Access Compliance Report

Public Rights-of-Way

Intersection ID: 30067	Main Street: OHAUS_CT	Cross Street: WATERS_TRAIL_DR	Location: NW
ADA ID: F6C7DA46A1D1	Ramp Type: BlendTrans2	Initial Pass/Fail: Fail	Overall Compliance: No
Severity Score: 10			
Codes/Mitigation Info/Possible Solution		Field Measurements/Component Compliance

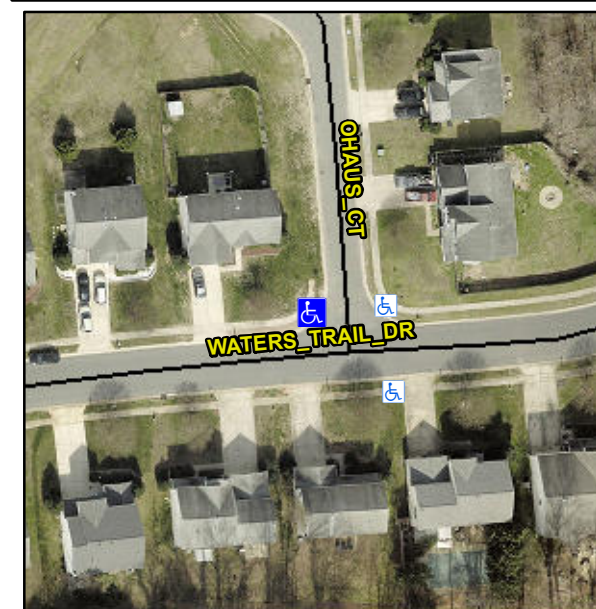
Not Found, R304.5.1, R304.5.3

Compliance	Description	Data	Compliance	Description	Data
N/A	Ramp Length (in)	94.5	Yes	BlendTrans Slope (%)	3.0
No	Ramp Width (in)	44.0	No	BlendTrans XSlope (%)	4.1
N/A	Flare Type LT	N/A	N/A	Flare Type RT	N/A
N/A	Flare Slope LT (%)	N/A	N/A	Flare Slope RT (%)	N/A
N/A	Flare Traversable LT?	N/A	N/A	Flare Traversable RT?	N/A
N/A	Landing Length (in)	N/A	N/A	DWS Provided?	N/A
N/A	Landing Width (in)	N/A	N/A	DWS Contrast?	N/A
N/A	Landing Slope (%)	N/A	N/A	DWS Length (in)	N/A
N/A	Landing X Slope (%)	N/A	N/A	DWS Full Width?	N/A
N/A	Landing Curb? (Y/N)	N/A	N/A	DWS Offset (in)	N/A
N/A	Shared Landing?	N/A			
N/A	Gutter Ponding?	N/A	N/A	Gutter Slope (%)	N/A
N/A	Gutter Lip Ht (in)	N/A	N/A	Gutter X Slope (%)	N/A
N/A	Painted X Walk1?	No	N/A	Painted X Walk2?	No
	X Walk 1 Direction	To E		X Walk 2 Direction	To S
	X Walk 1 Width (in)	N/A		X Walk 2 Width (in)	N/A
	X Walk 1 Slope (%)	2.3		X Walk 2 Slope (%)	3.3
	X Walk 1 X Slope (%)	2.6		X Walk 2 X Slope (%)	3.0

N/A	Ramp inside XWalk1?	N/A	N/A	Ramp inside XWalk2?	N/A
	Road Slope (%)	3.5		Clear Space?	N/A
	Road X Slope (%)	2.0	N/A	Clear Space to XWalk (in)	N/A
N/A	Any Obstructions?	N/A	N/A	Storm Grate/Utility Hazard?	N/A
	Obstruction Type			Storm Grate/Utility Type	
		N/A			N/A
			Yes	Surface Condition? (G/P)	Good
			No	Curb Slope (%)	12.4

Remove & Replace Curb Ramp With Two New Directional Ramps or Equivalent.
